**BOARD OF ZONING ADJUSTMENT
STAFF REPORT**

5804

Rangeline Business Park, LLC

3816 Abigail Drive
(North side of Abigail Drive, 750'± East of Rangeline Service Road).

SITE PLAN

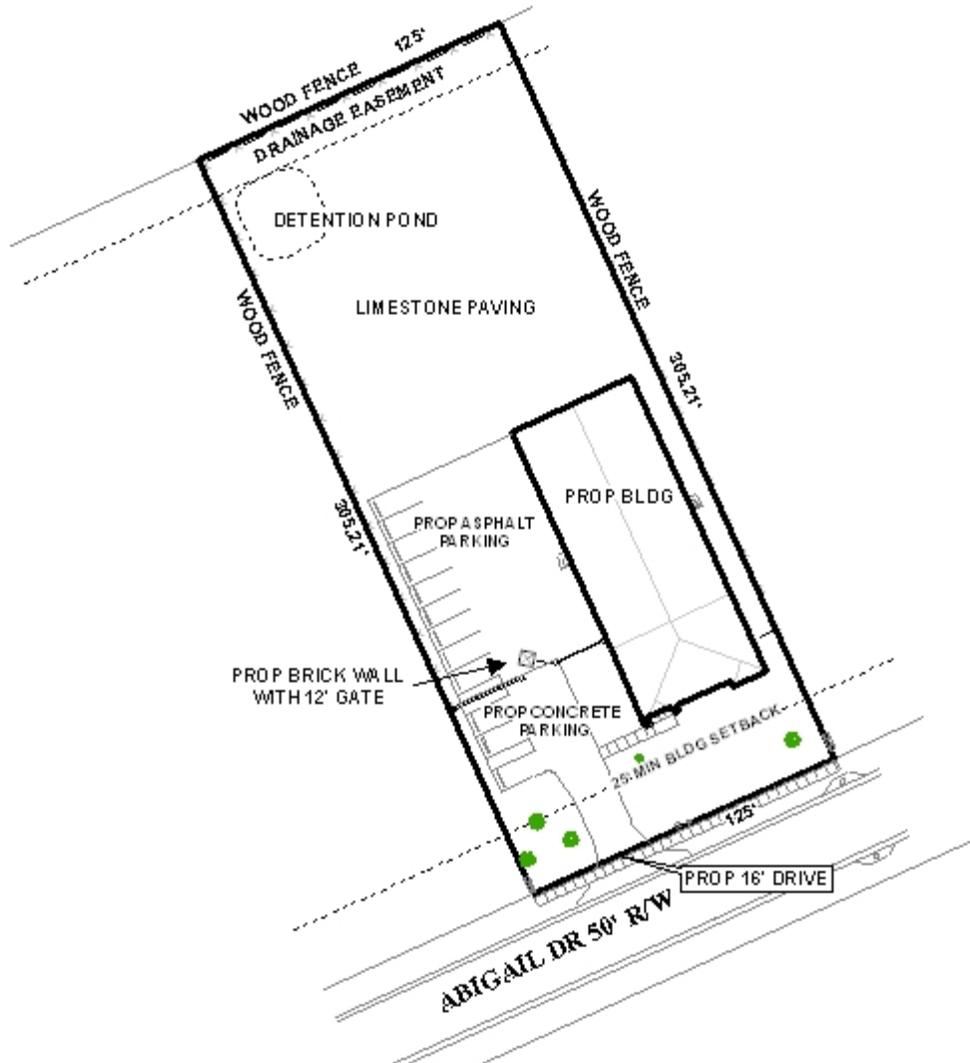
When the last exception to the City standards was granted to the development, it was stated that no additional variances would be given. The driveway(s) must be 24' wide and have two 20' radii.

The site is currently being developed for office/warehouse use. When the building permit was approved in February 2012, the approved site plan showed a 24' wide entrance drive and gate clearance, and the currently proposed lay down yard was simply illustrated as being undeveloped therefore did not require an 8' high privacy fence, and was illustrated as having a 6' high chain link fence.

requirements. With regard to the driveway width, the applicant states that deliveries will not be by 18-wheelers, but only by FedEx-type trucks, and that traffic volume will be extremely low. The applicant also proposes an aggregate-surface lay down yard in the rear of the property to be enclosed by a 6' high privacy fence, although no reason is given for such. The applicant states that while the site is currently being developed, there is no specific tenant to occupy it at this time, therefore there is no justification for the approval of the aggregate surfacing or the reduction in fence height. It is simply stated it is the applicant's desire to have this site and all other sites in the original subdivision designed similarly. It should be noted that a similar request was approved at the Board's August 6, 2012 meeting. In that request, the case also began with a City-compliant site plan, which was not followed during construction – the variance was required after construction was complete.

With regard to the requests for the substandard driveway width, maneuvering area, and gate clearance variances, the fact that the applicant is currently proposing to develop the site with disregard to the site plan originally approved by the City of Mobile does not constitute a hardship imposed by the site. The site plan originally approved did have the proper widths for the associated drive, maneuvering area and gate clearance, and no lay down yard was illustrated. Any hardships now present would be self-imposed by the applicant.

With regard to the proposed aggregate lay down yard, if no 18-wheelers are proposed to enter the site, with FedEx-type delivery trucks being the largest proposed to make deliveries, there is no way any heavy equipment or materials could enter or would have to be stored outdoors; thus a lay down yard would not be required. In similar instances where surfacing variances have been sought in I-1 districts, heavy equipment movement and materials storage have been viable reasons for the approval of surfacing variances. There is no justification given in this application to support the need for an aggregate or any other type-surface lay down yard. If such were given for heavy equipment and materials storage, which would require large truck delivery, then that would be further reasoning for the requirement of the standard 24' widths on the driveway, maneuvering area, and gate clearance.

Furthermore, any future occupant of the site may wish to use larger vehicles/trucks, despite the "as-built" substandard nature of the site. Thus the applicant is restricting a tenant's ability to use the site by proposing substandard development of the site. Also, the proposed gate and maneuvering area may not provide adequate room for a FedEx-type truck to turn around on the site. The proposed layout could also prevent any future placement of a dumpster on the site due to access problems. It should also be noted that the provided handicapped parking does not appear to comply with Americans with Disability Act (ADA) standards, unlike the previously approved site plan.

RECOMMENDATION: Based on the preceding, this application is recommended for denial.
